# IEEE 1547-2018 Category III – Proposed Amendment to Allow Faster Trip Times

July 8, 2019

PJM DER Ride Through Task Force

# Voltage % Nominal IEEE 1547-2018 Cat III w/ Proposed Amendment UV1 and UV2

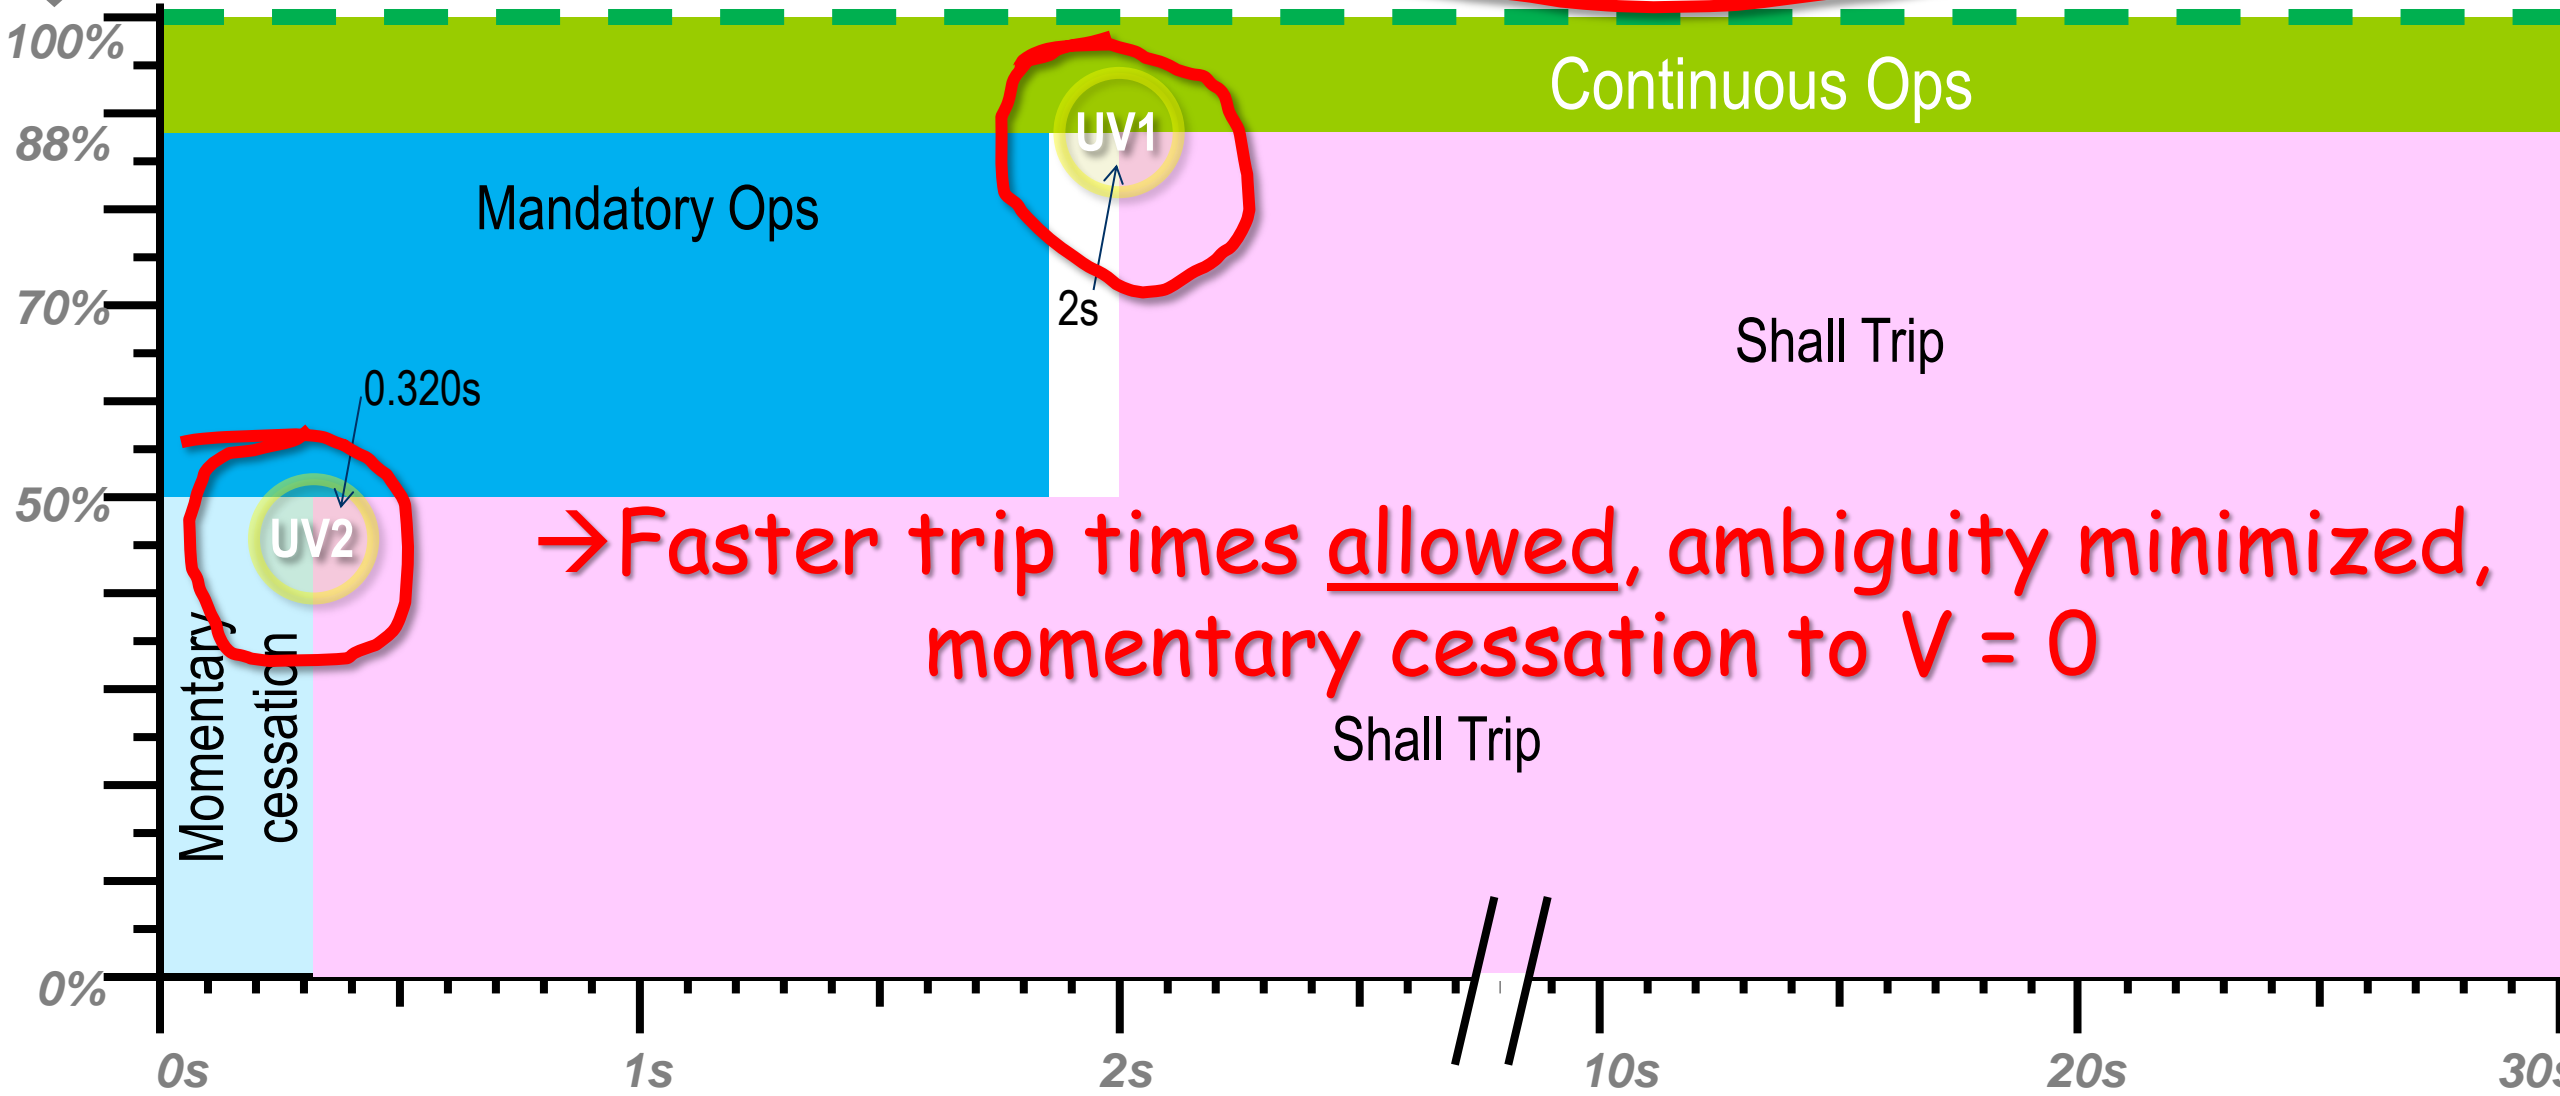
→ Faster trip times allowed, ambiguity minimized, momentary cessation to  $V = 0$
